9.5 DISPLAY SECTION

(1) CDJ-2000 and CDJ-2000/2 are constructed the same except for the following:

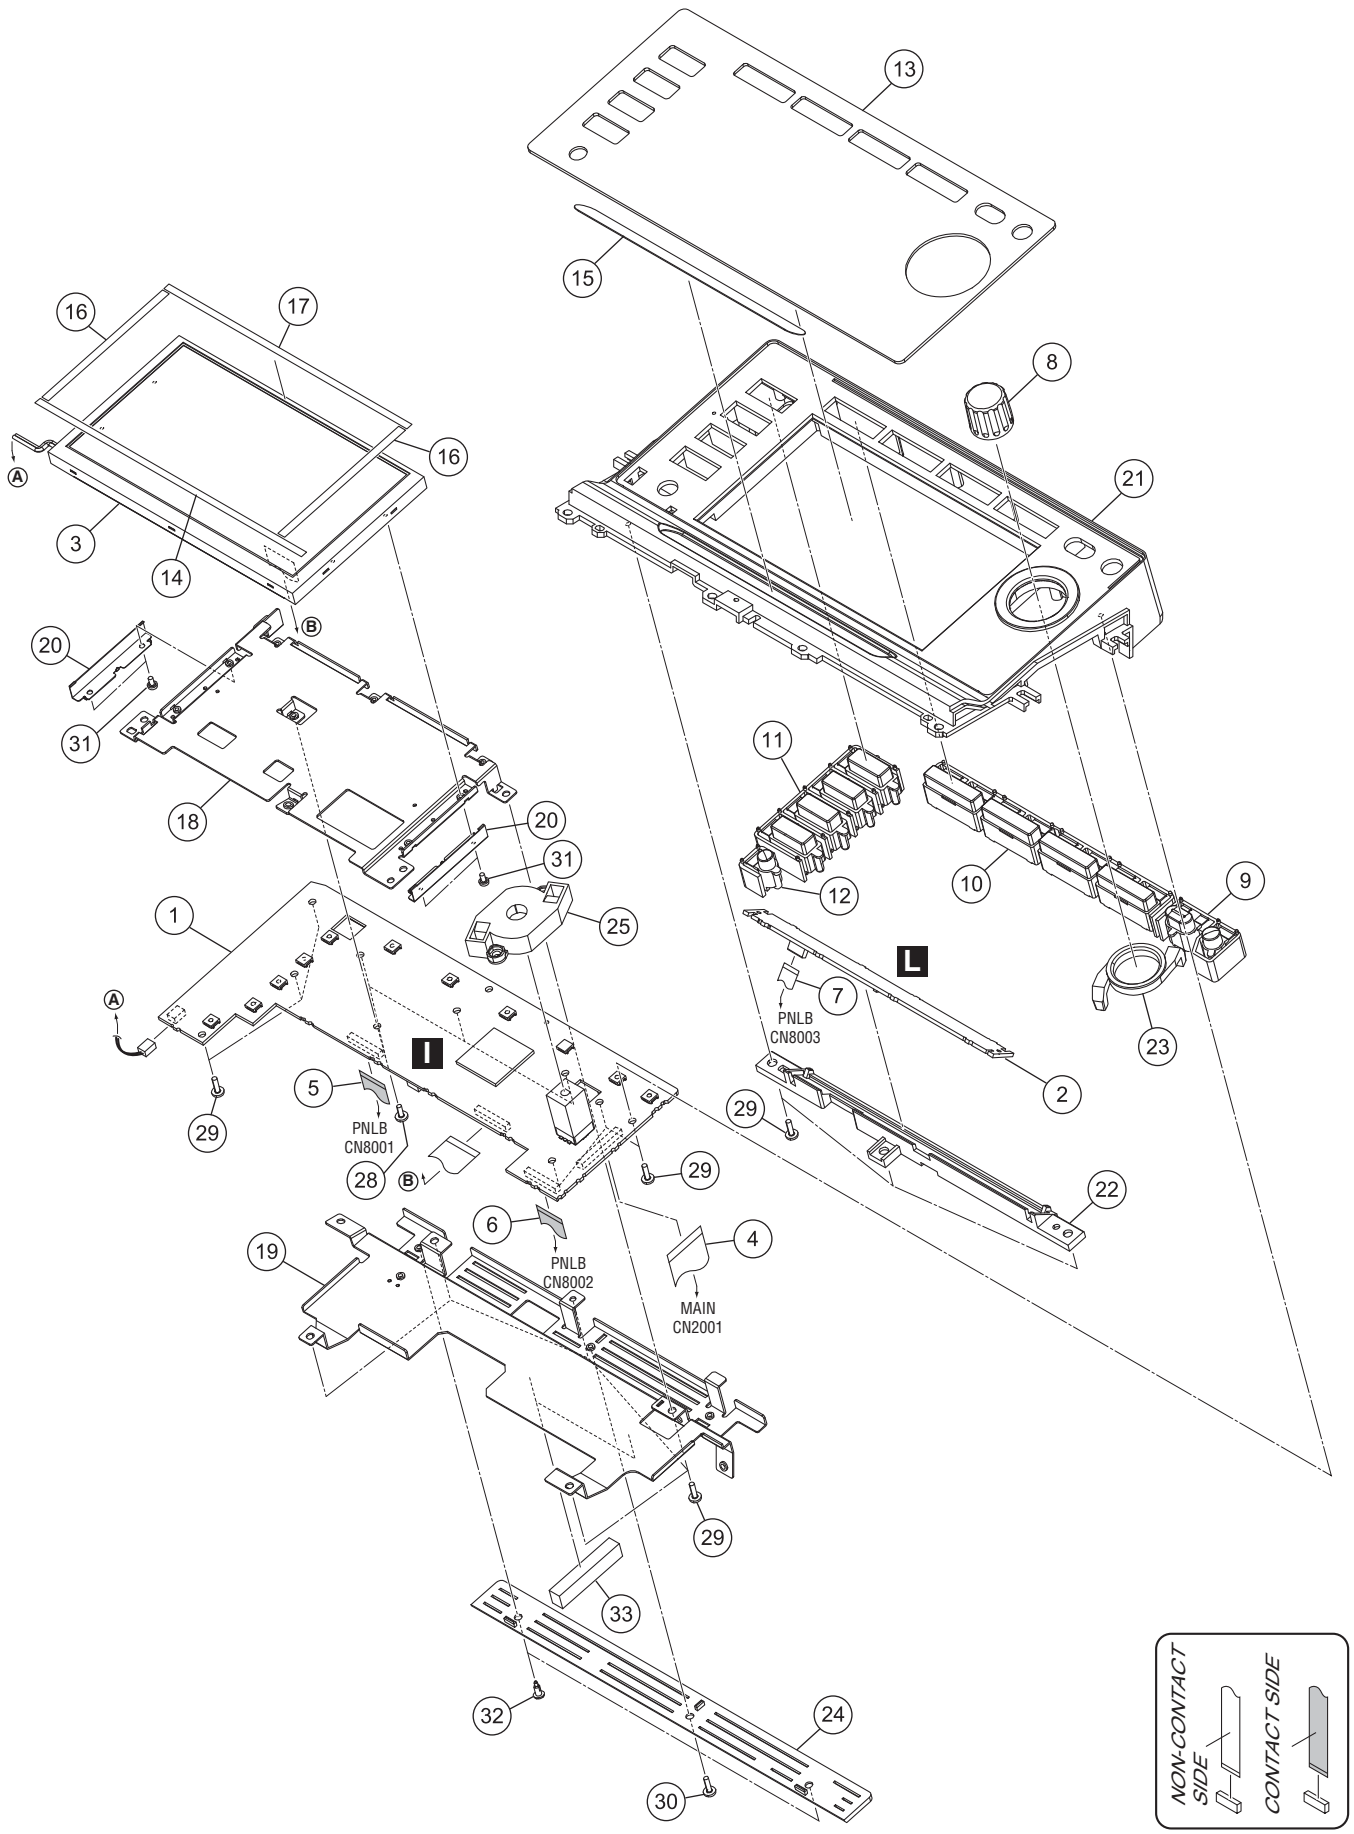
Mark	No.	Symbol and Description	CDJ-2000 /CUXJ,/SYXJ8,/FLXJ,/KXJ,/AXJ5	CDJ-2000 /UXJCB2,/SYXJ82,/FLXJ2,/KXJ2,/AXJ52	Remarks
		PCB ASSEMBLIES			
NSP		1..TFTA Assy	DWM2355	DWM2445	
	P77-2	2..SDCB Assy	DWX2980	DWX3293	*2
	P83-1	2..TFTB Assy	DWX2882	DWX3291	*1
	P83-2	2..CDCB Assy	DWX2987	DWX3292	*1
		DISPLAY SECTION			
	P83-3	LCD	DWX3126	CWX3970	
	P83-17	LCD Packing (Top)	DEC3193	DEC3376	
	P83-18	LCD Stay	DND1263	DND1267	
	P83-19	Rear Bracket	DND1264	DND1268	
	P83-20	LCD Holder	DNH2850	Not used	
	P83-21	LCD Panel	DNK5319	DNK5951	
	P83-30	Screw	BBZ30P060FTB(x 22)	BBZ30P060FTB(x 21)	
	P83-31	Screw	BSZ20P040FTB	Not used	
		Screw	Not used	BSZ30P040FTC	No. 1
		40P FFC	Not used	DDD1541	No. 2
		Fitting/LCD	Not used	DNH2992	No. 3

*1 Refer to “3.PCB PARTS LIST”, “5.SCHEMATIC DIAGRAM” and “6.PCB CONNECTION DIAGRAM”.

*2 Although DWX2980 and DWX3293 are different in part number, they are constructed same. Refer to “CDJ-2000/CUXJ(RRV3999)”.
